## **V P Subdivision**

***Revised for the February 18<sup>th</sup> meeting:***

APPLICATION NUMBER 5 DATE February 18, 2016

# DETAIL SITE PLAN

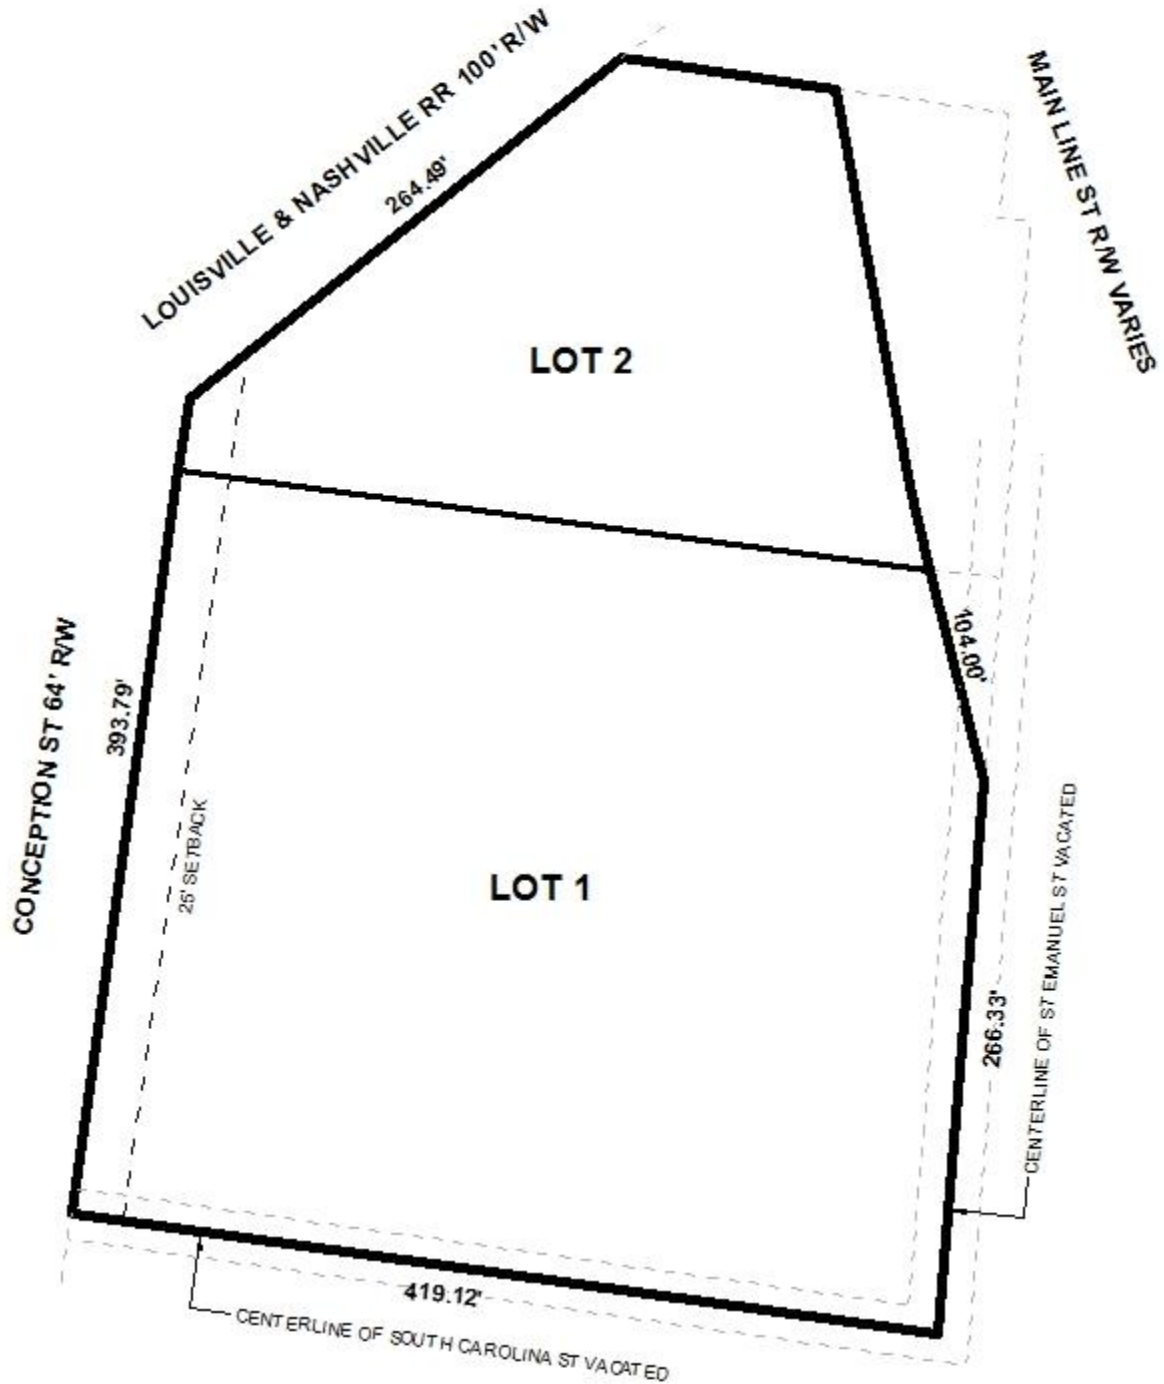
*The revised plat illustrates the proposed 2-lot, 4.61± acres subdivision, which is located on the East side of South Conception Street, 225'± South of North Carolina Street, in Council District 3. The applicant states the site is served by city water and sewer services.*

*The purpose of this application is to create two legal lots of record from one metes-and-bounds parcel. The applicant is also requesting a waiver of the 25' minimum building setback requirement along the Main Line Street Bridge, stating that elevation of the roadway and existence of a railroad prohibits access to both Main Line Street and its adjacent Ezra Price Boulevard as justification for the request.*

*The proposed Lot 2 has frontage along South Conception Street, a minor street with curb and gutter. A compliant 64' right-of-way is depicted and, as such, no dedication is required. Right-of-way width varies along Main Line Street due to right-of-way acquisition to construct the aforementioned bridge; as such, additional dedication should not be required.*

*It should be noted that shared access between proposed Lots 1 and 2 is necessary as Lot 2 would otherwise not have access to a public street due to limited frontage. An application for a Planned Unit Development to allow shared access between lots and to allow multiple buildings on a single building site was received by Staff past the January 19<sup>th</sup> deadline. As such, the Planned Unit Development will be heard at the March 3<sup>rd</sup> meeting of the Planning Commission.*

*The 25' minimum building setback line is shown for both lots along South Conception Street on the preliminary plat and should be retained on the Final Plat, if approved.*

*It should be noted that Lot 2's frontage along the CSX Railroad mainline coincides with the proposed Royal Street South Major Street, which is proposed to have an 80 foot right-of-way. Considering no time frame for development of the major street is known, staff recommends no dedication of the right-of-way at this time; however, a 25' minimum building setback line is recommended.*

- 1) placement of a note on the Final Plat stating that Lots 1 and 2 are limited to two shared curb cuts to South Conception Street, and denied access to all other abutting rights-of-way;*

- 7) *provision of a revised PUD site plan, if necessary, prior to the signing of the Final Plat;  
and*
- 8) *depiction of a 25 foot minimum building setback line along the CSX Railroad mainline  
right-of-way, where Lot 2 abuts the railroad, to accommodate a proposed major street.*
